<b>ADDENDUM TO THE CONTRACT DOCUMENTS</b>	<b>Page Number</b> <b>1</b>	<b>No. of Pages</b> <b>11</b>
<b>Addendum No. One (1)</b>	<b>Date Addendum Issued: March 30, 2016</b>	
<b>Issuing Office</b> Alaska State Parks, Design & Construction Section 550 West 7 <sup>th</sup> Ave., Suite 1340, Anchorage, Alaska 99501 Phone: 269-8731 Fax: 269-8917	<b>Previous Addenda Issued</b>  <b>None</b>	
<b>Project: Kasilof River SRS Riverbank Restoration</b> <b>Project No.: 73057-1</b>	<b>Date and Hour of Quotes Due</b> <b>April 5, 2016 2:00pm prevailing time</b>

### The Bid Documents Are Modified As Follows:

Project Name: **Kasilof River SRS Riverbank Restoration**

Project Number: **73057-1**

SHEET  
6  
OF 15 SHEETS

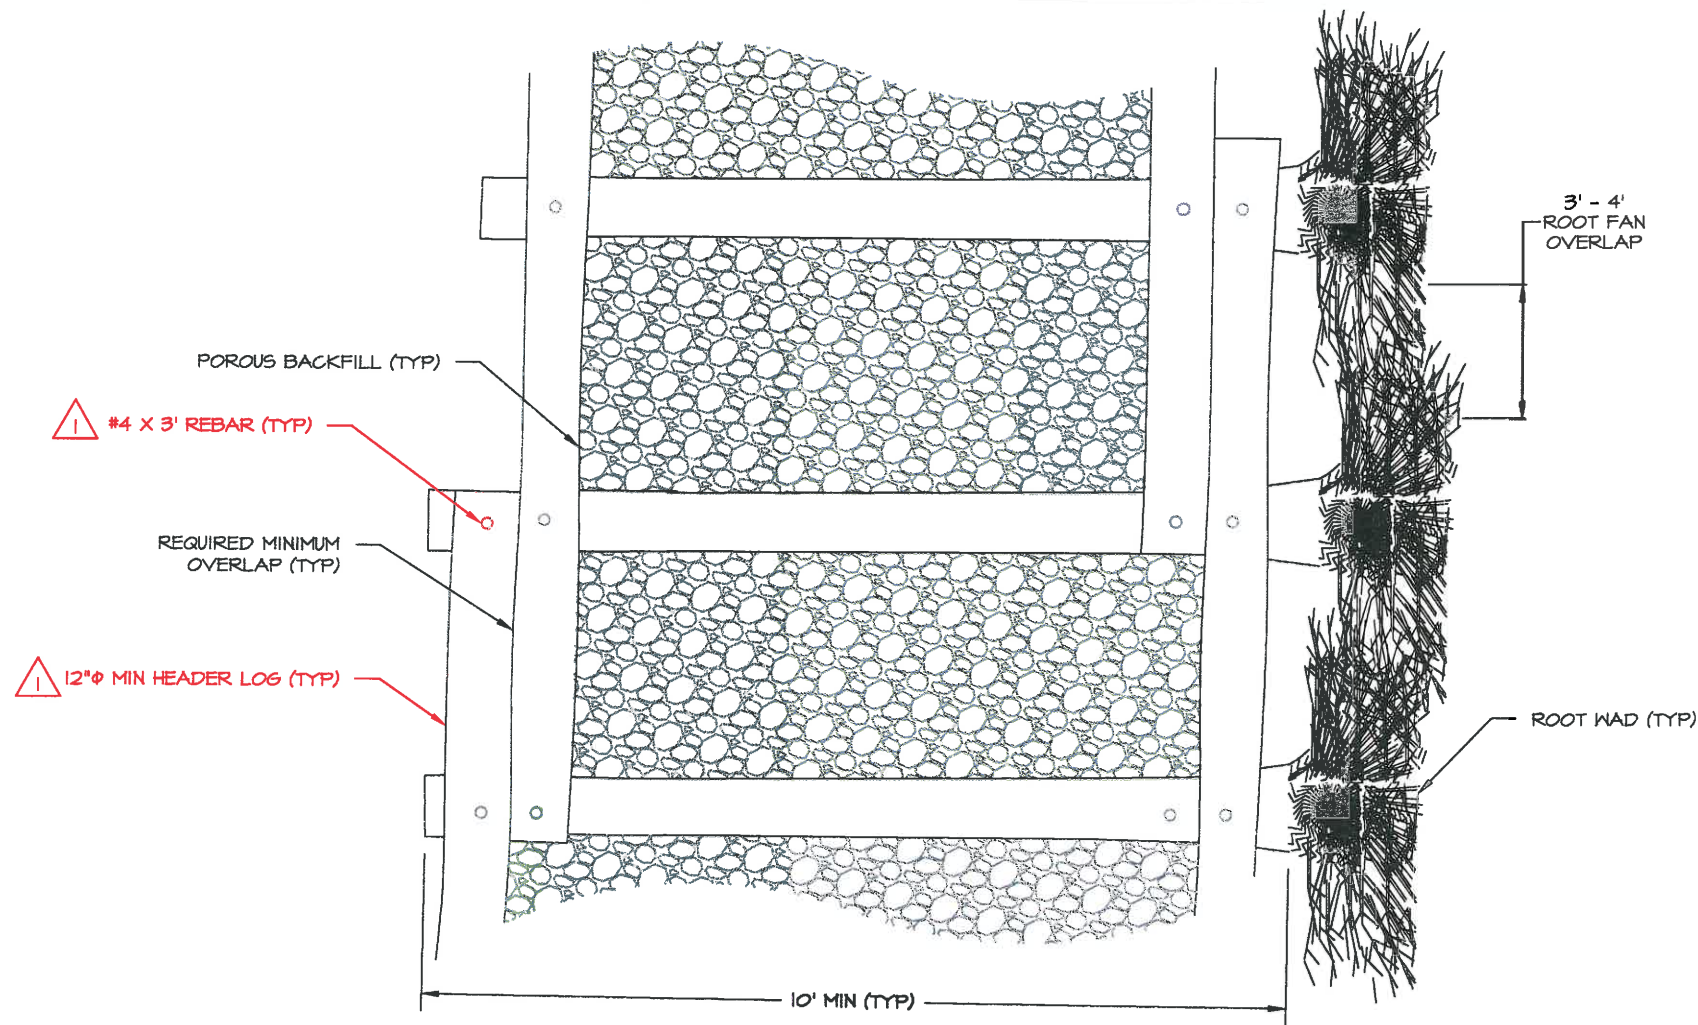
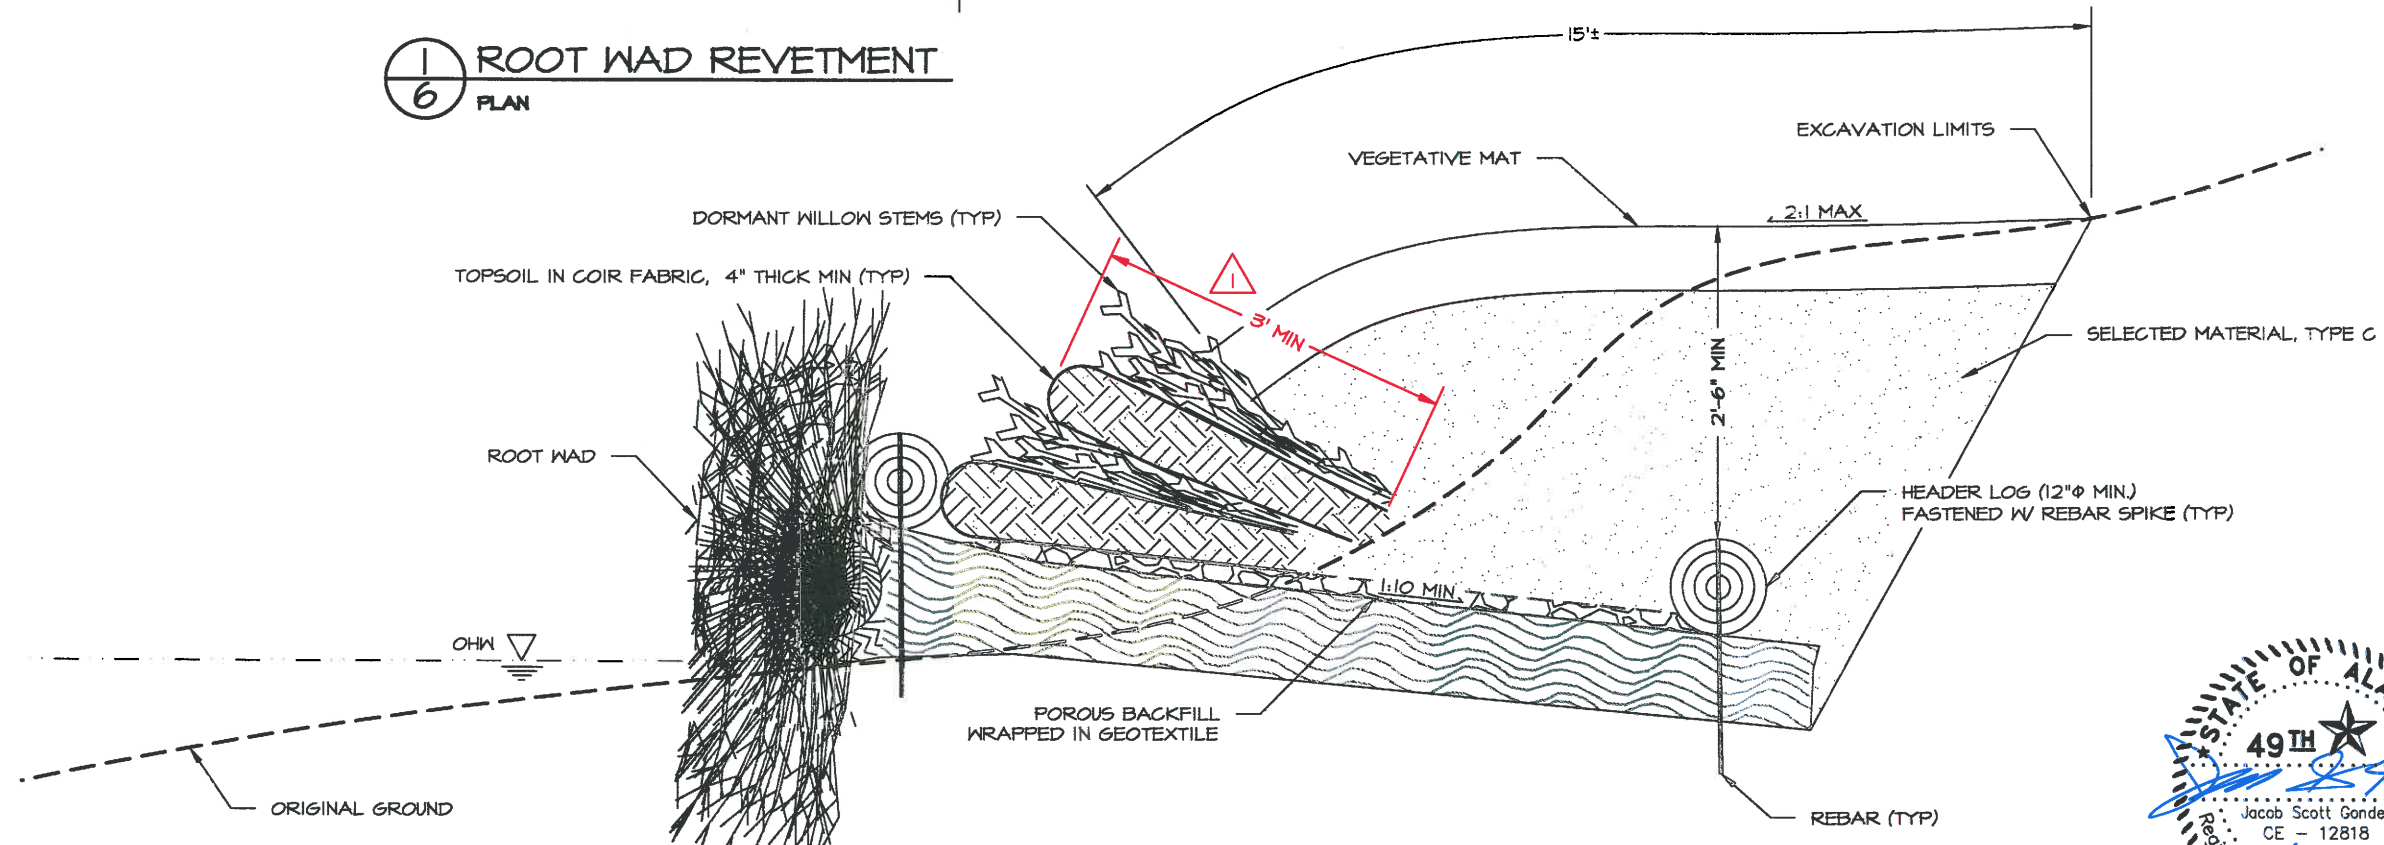
Replace sheet 6 of the Plans with Addendum No. 1 – Attachment F
